Proposed 4 ' high metal fence

## STAFF ANALYSIS

Neighboring fence visible cross the street

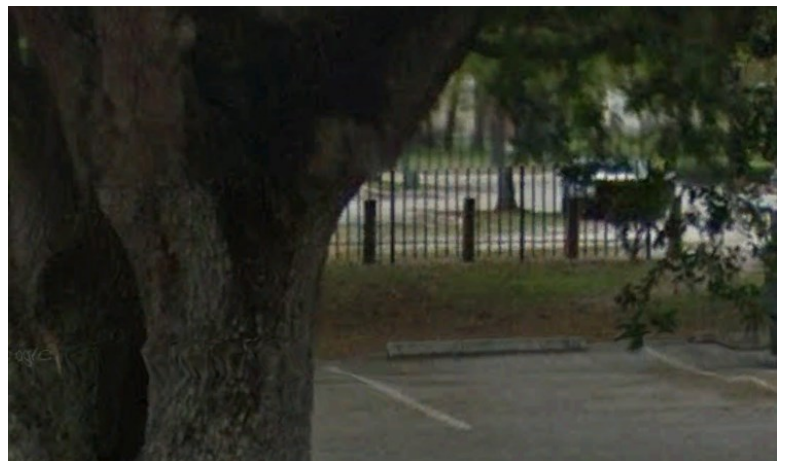
Requested COA seek to install 4 foot high metal fence that is compatible in appearance with fencing on neighboring property. Therefore, based upon Secretary of Interior Standards 9, staff recommends that the Board approve the request for of a 4' high metal fence on the front yard, along the front and side property lines.
